**TOWNSHIP OF SOUTH WHITEHALL
LEHIGH COUNTY, PENNSYLVANIA**

PLANNING COMMISSION

APRIL 11, 2024

**AESTHETIC SURGERY ASSOCIATES PROPOSED MEDICAL OFFICE
BUILDING
MAJOR PLAN 2023-106
ATTACHMENTS**

SHEET TITLE:
**UTILITY
PLAN**
SHEET NUMBER:
C-501
REVISION 2 - 3/14/2024

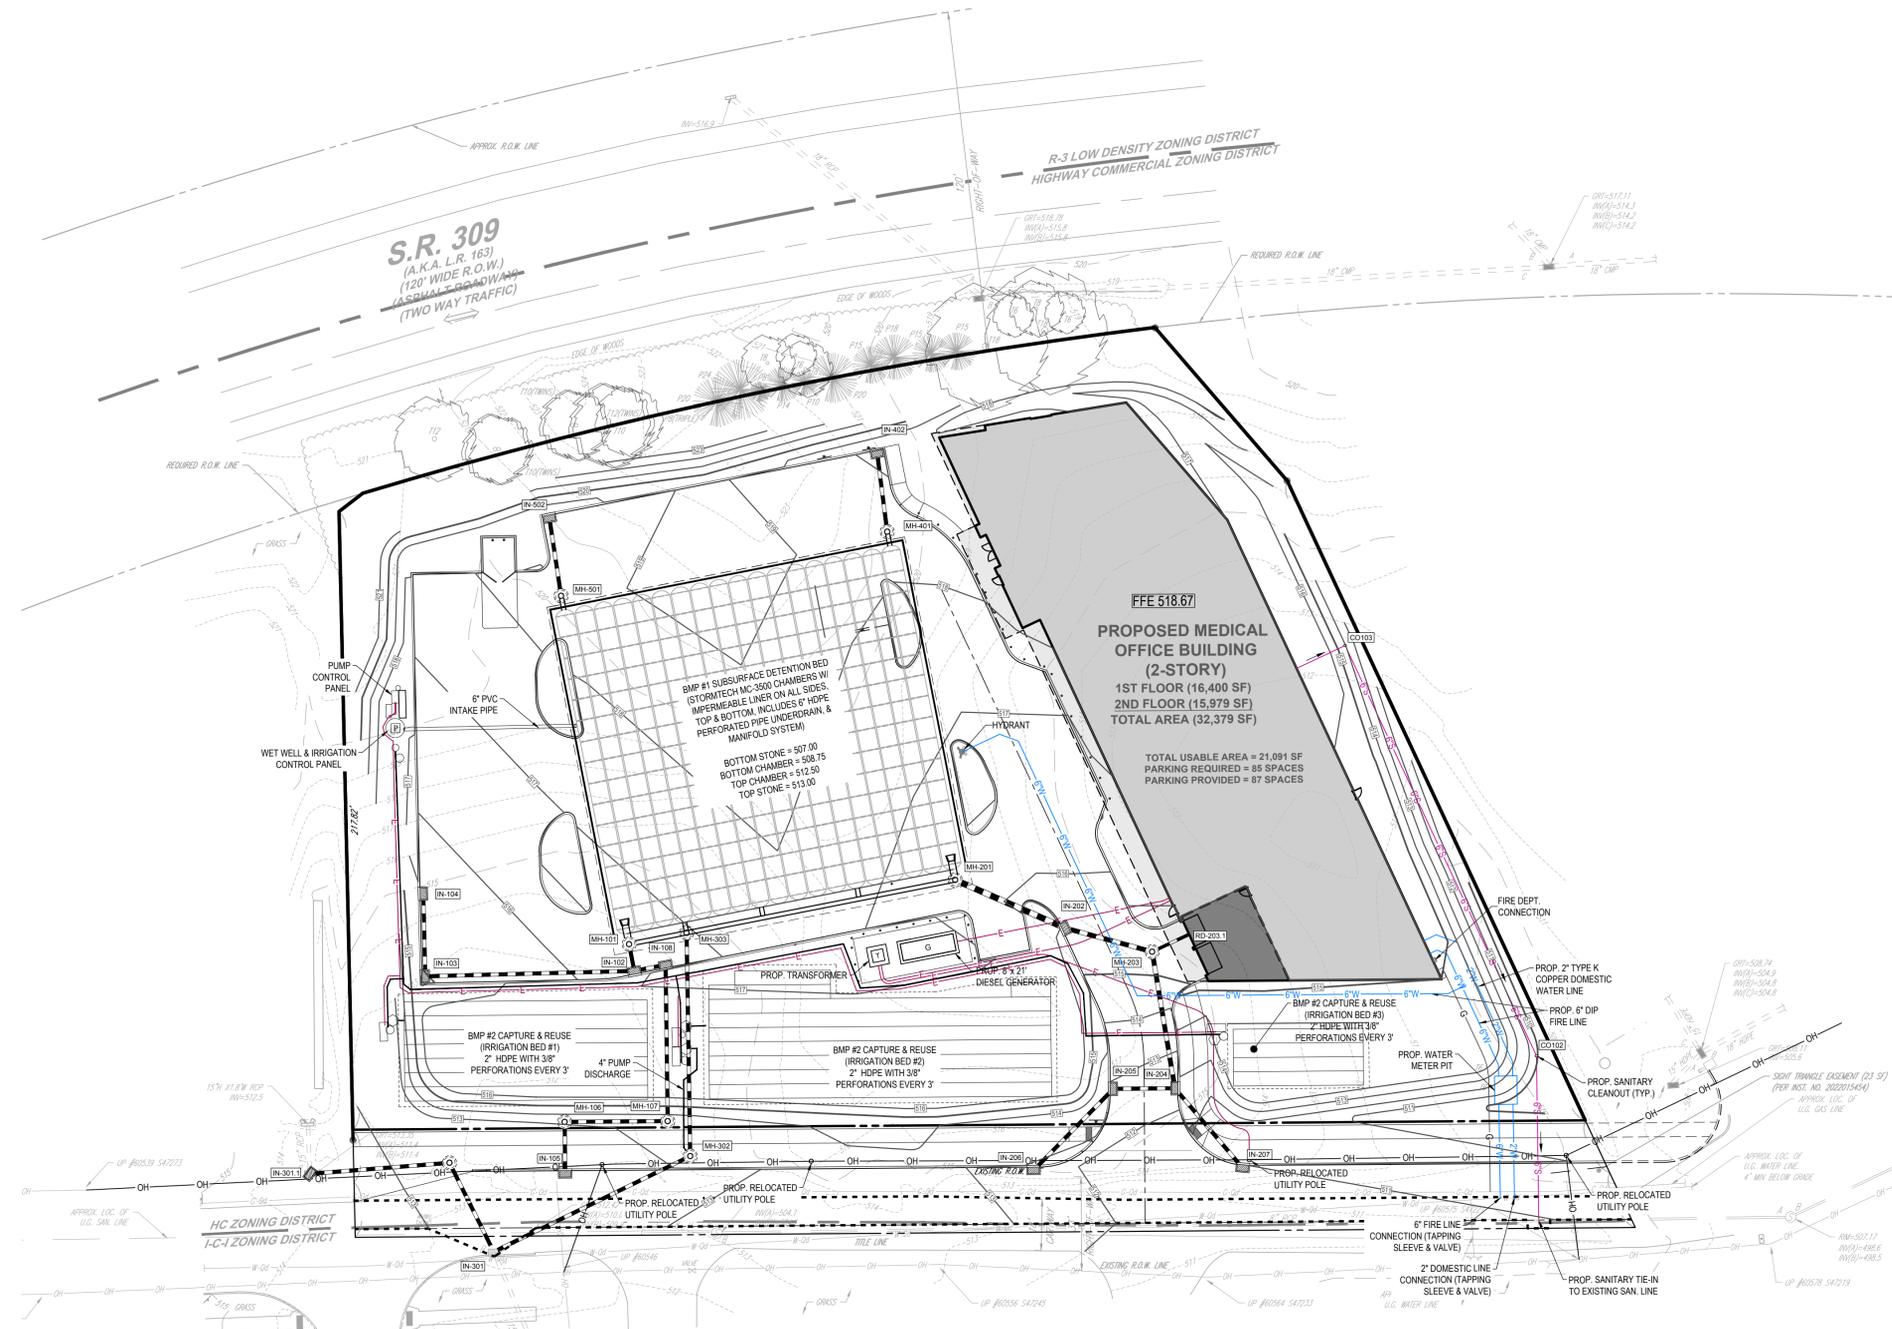
1. Utility Plan Sheet 501 Revision 2 - 03/14/2024: 12" water line is shown in appears to be in the wrong location. Determine the existence and positions of the SWT 12" water main, which we believe to be outside of the paved area of Hausman Rd.
